Classification:  
 EL17-011b

Reference:  
 ITB17-029b

## 2017 QX30; PUSH-BUTTON IGNITION SWITCH MID-YEAR CHANGE

**APPLIED VEHICLES:**                    2017 QX30 (H15)

Figure 1

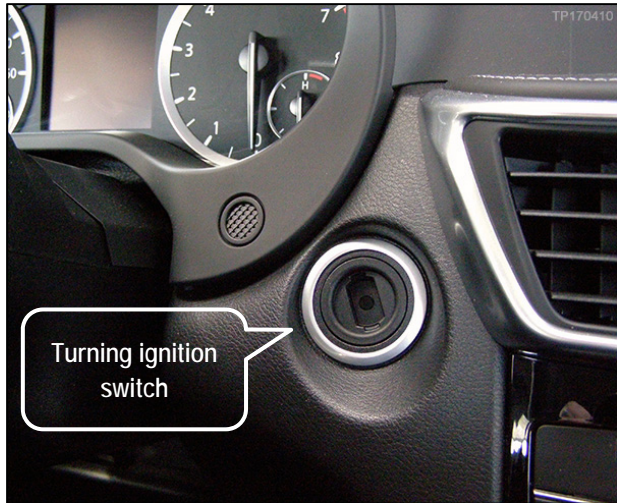
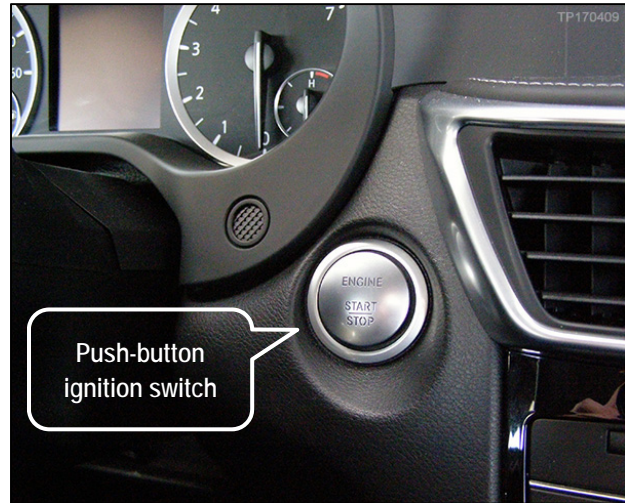
Vehicles produced on November 3, 2016 and after (see VIN information on page 2) are equipped with a push-button ignition switch instead of a turning ignition switch.

**NOTE:** See Figures 1 and 2 on page 2 to view images of both ignition switches.

Vehicles built **BEFORE**  
VIN: SJK(\*)H5C(\*\*)HA 029900

Vehicles built **AFTER**  
VIN: SJK(\*)H5C(\*\*)HA 029899

- Do NOT retrofit the push-button ignition switch to vehicles produced before the application date. Please reference Infiniti Parts and Service Bulletin IPSB/16-422.
- Modifications to the ignition switch are unauthorized, and may violate Federal law by making inoperative a device installed in compliance with Federal safety standards.
- Damage or failure due to changes or modifications to the ignition switch system are not covered under the terms of the warranty.
- Damage or failure due to changes or modifications to the ignition switch system are not subject to indemnification under the terms of the Infiniti Dealer Sales and Service Agreement.
- Retailers may be obligated under their Sales and Service Agreement to indemnify Infiniti for any damages, injuries, or deaths caused by modification of the ignition switch system.
